Seismic Walkdown Checklist (SWC)Equipment ID No. 2H21-P021 Equip. Class¹ 18Equipment Description RHR Instrument RackLocation: Bldg. REACTOR Floor El. 87 Room, Area SE Diagonal Unit 2

Equipment ID No. 2H21-P021 Equip. Class¹ 18

Equipment Description RHR Instrument Rack

3: Support Pedestal (2R43-B001A)

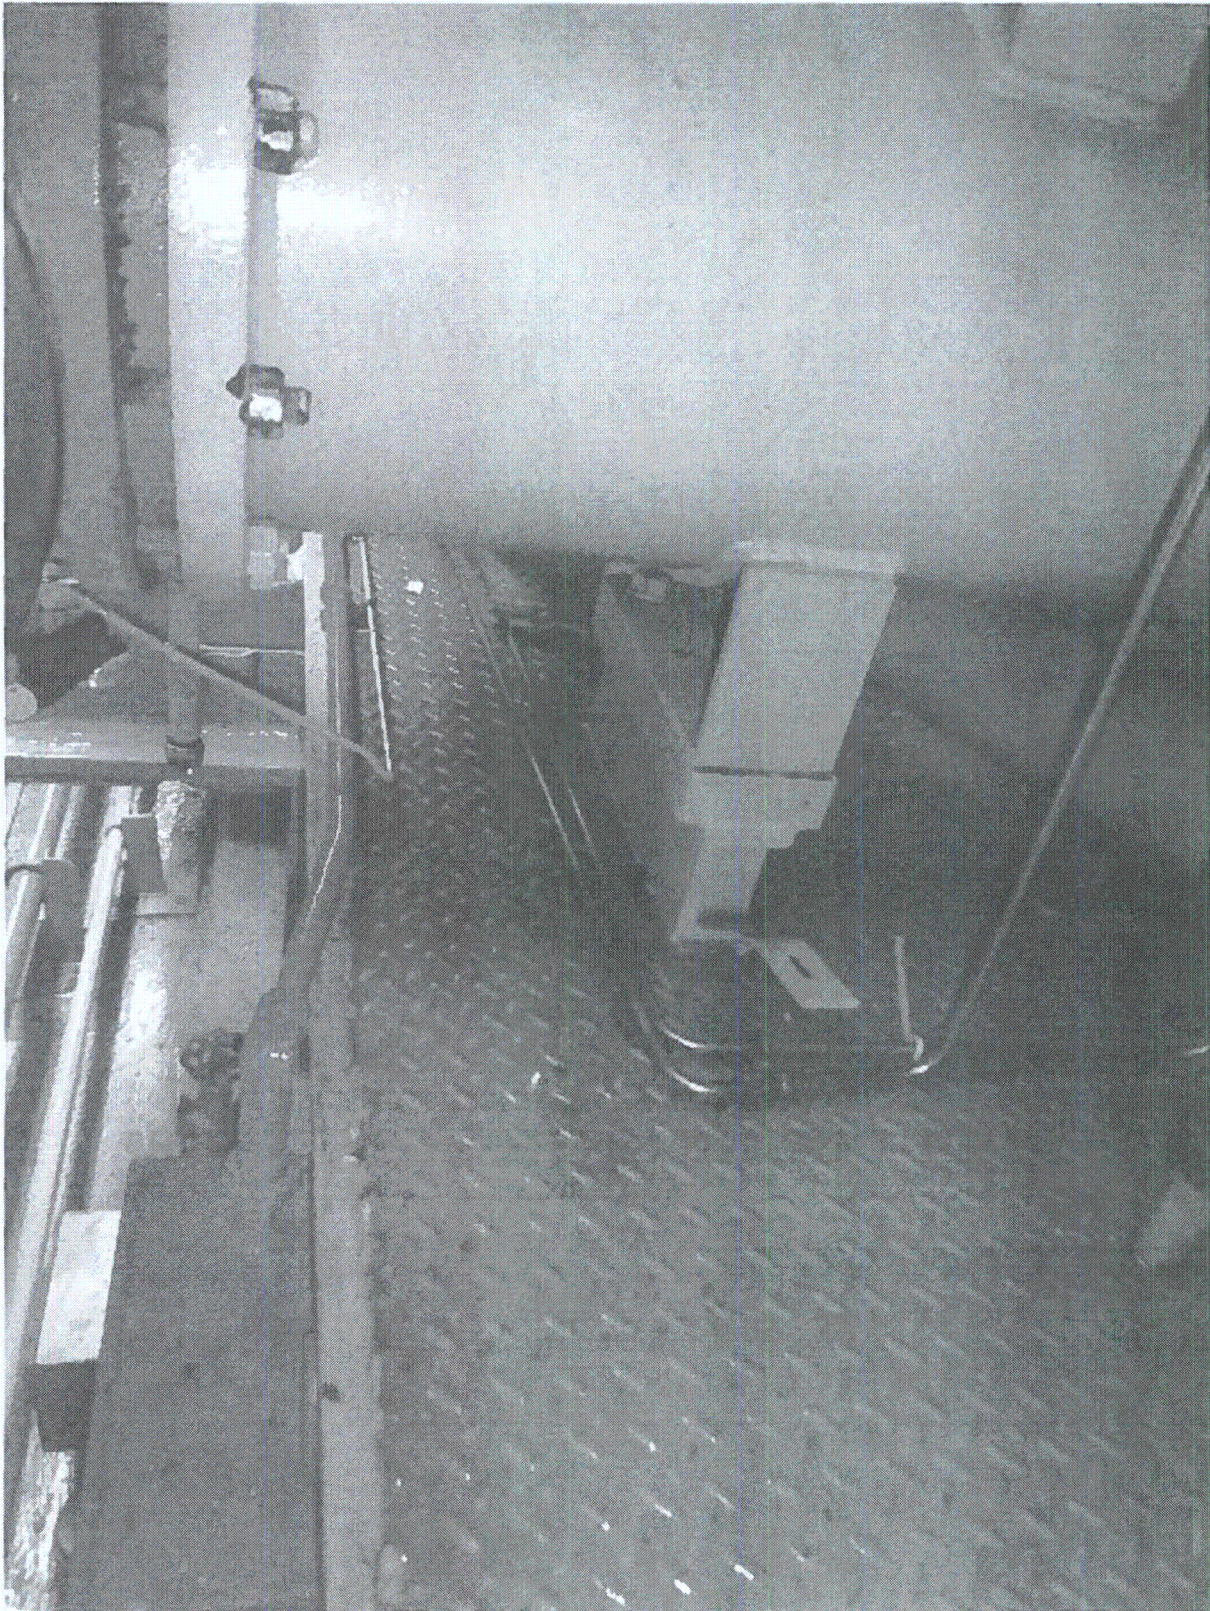
2. Is the anchorage free of bent, broken, missing or loose hardware? Y N U N/A
The heat exchanger is bolted to a steel pedestal, which is welded to the deisel generator steel framing.

4. Is the anchorage free of visible cracks in the concrete near the anchors? Y N U N/A
Equipment is welded to steel beams supporting the diesel generator (see photograph 3).

4: Three Heat Exchange System Supported Together (2R43-B001A)

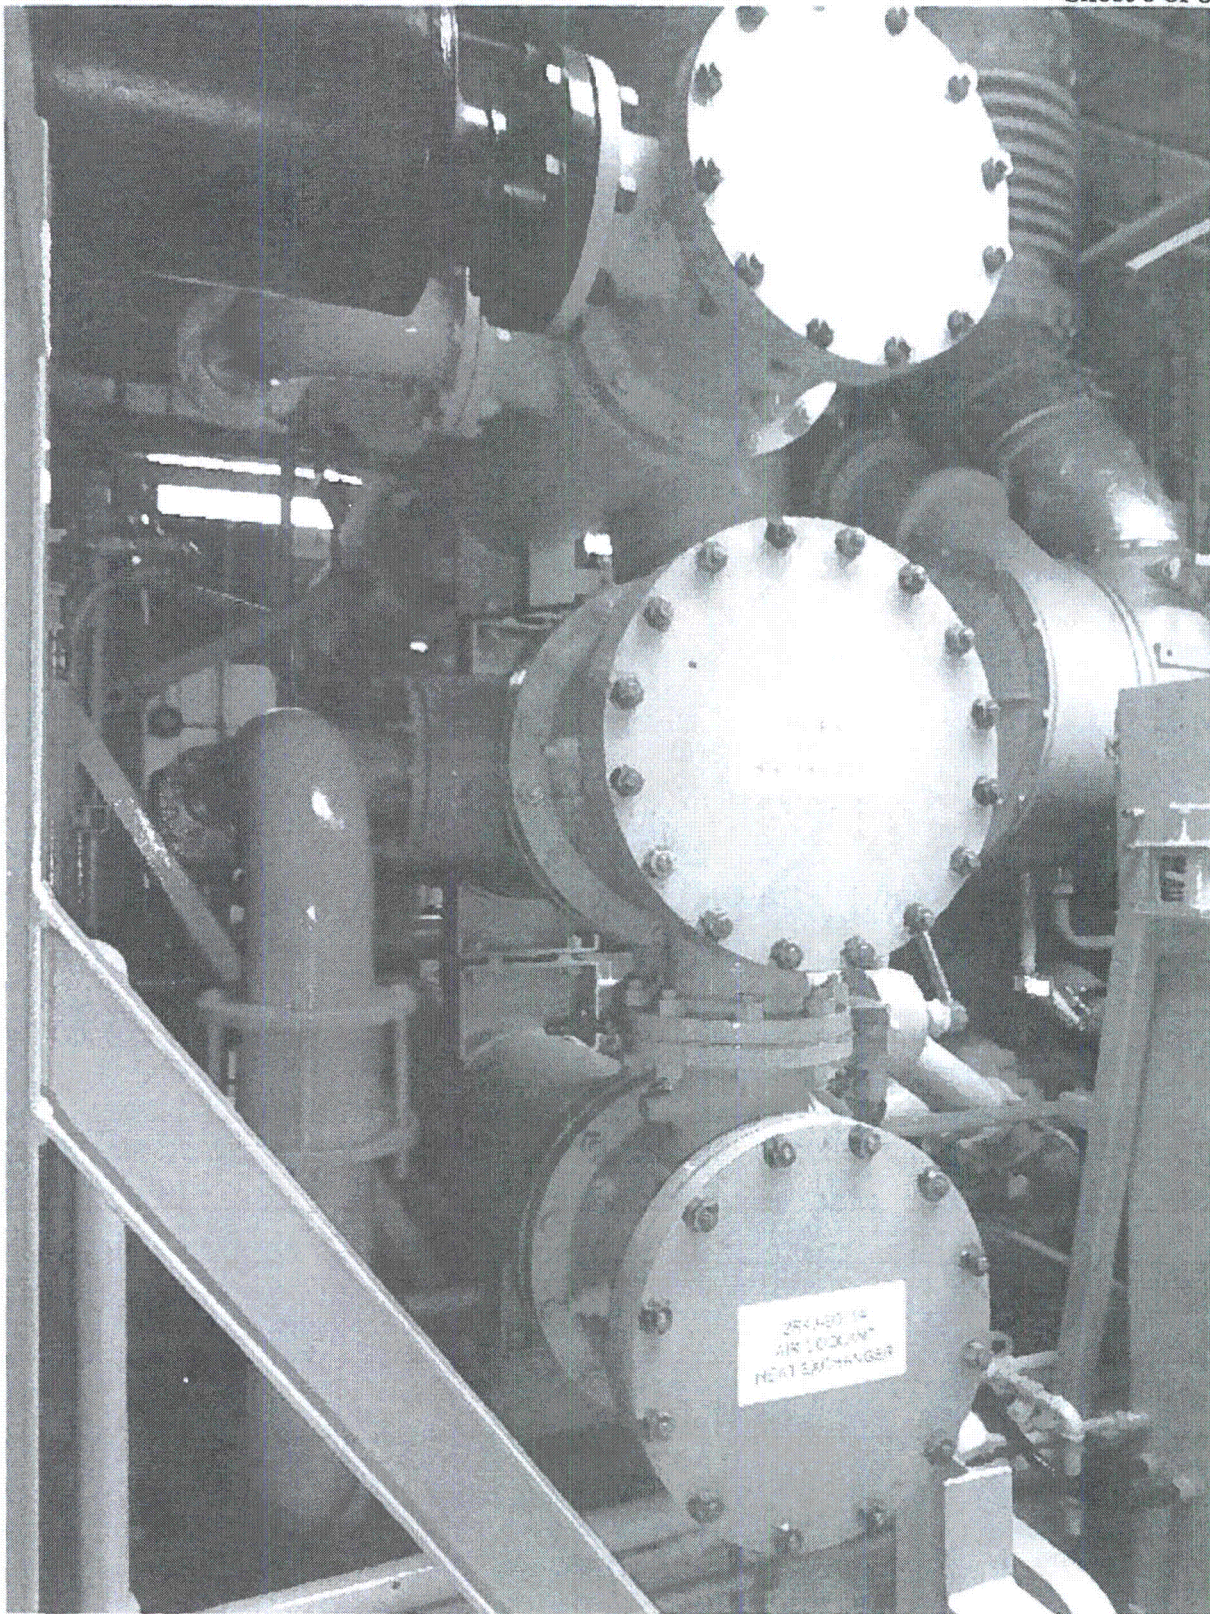
- 7. Are soft targets free from impact by nearby equipment or structures? Y N U N/A
Lube oil heat exchanger (2R43-B002A) and jacket water heat exchanger (2R43-B003A) are supported by the 2R43-B001A heat exchanger pipe with welded steel pedestals between them (see photograph 4). The three systems will act together during a seismic event and will not cause impact to one another. This is not a seismic concern.
